OWNER'S RENOTIFICATION LETTER

Re.: NHTSA Safety Recall Program-Campaign number **04V - 424**
Van Hool coaches types T2145 - C2045 : **Power Steering Lines.**
Vin # (45992)

SERVICE BULLETIN No.1153

COACH MODEL	: T2145 and C2045
BULLETIN TYPE	: Safety Recall Program – NHTSA campaign number 04V-424
MANUAL & SECTION	: Maintenance Manual: Chapter 7 - Steering Spare Parts Manual: Section 651209 Steering – hydraulic system
PARTS BOOK REVISION	: No
DATE	: December 3, 2004
SUBJECT	: Power steering line - inspection
TERMS & CONDITIONS	: Refer to the Warranty Information in this Bulletin.

Figure 2: Fitting crimp length L should be at least 0.944 inch

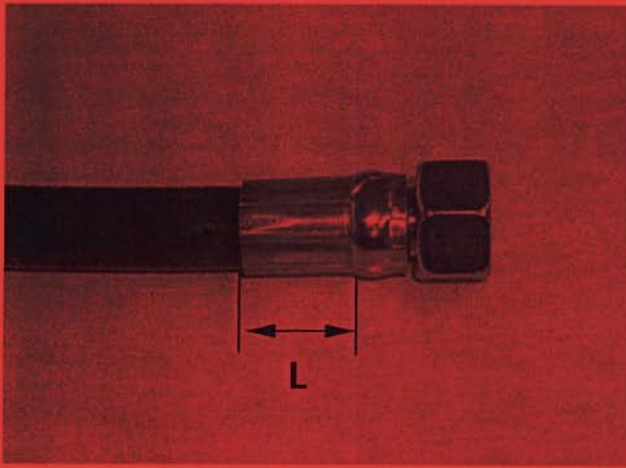
1. the crimp length of the affected hose fittings, which should be at least 0.944 inch (24 mm) as indicated in Figure 2.
2. the crimp diameter of the affected hose fittings, which should be 0.893 inch (22.7 mm) maximum as indicated in Figure 3.

1. a fitting with a crimp length *less* than the above-mentioned value (see Figure 4) should be put out of service.
2. a fitting with a crimp diameter *higher* than the above-mentioned value should be put out of service.

Figure 12: Spare line duct at the rear of the coach with new central tunnel line installed

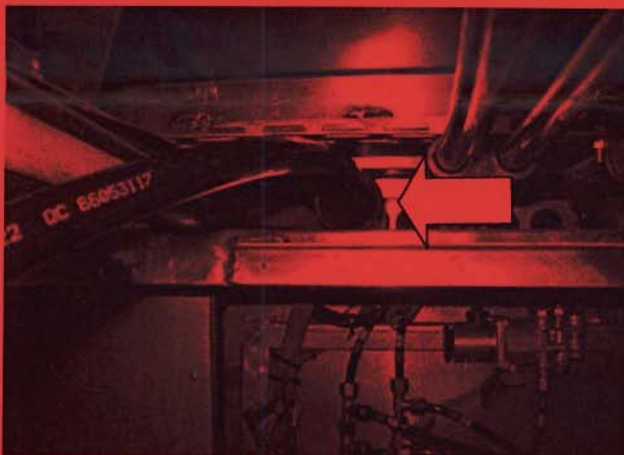
- 1) After disconnecting the old central tunnel line from the engine compartment line at the rear, and the chassis to steering gearbox line at the front, blow it through with compressed air (30 psi maximum) while an assistant catches the fluid inside the line in a suitable container. Cap the line (using the plastic caps VH 637101760, which come with the new hoses) to avoid fluid spillage. Leave the line in place. Do add a label at both ends indicating that this line should not be re-used.
- 2) Run the new hose through the spare line duct above the fuel tank at the front (see Figure 11).
- 3) Next run the new hose along the old central tunnel line in the luggage compartment.
- 4) Finally, run the new hose to the engine compartment via the spare line duct above the drive and tag axles (see Figure 12).

- 5) Secure the new line to the old one with tie wraps.
- 6) If no further hoses need replacing, add hydraulic fluid and bleed the system as per attached procedure.
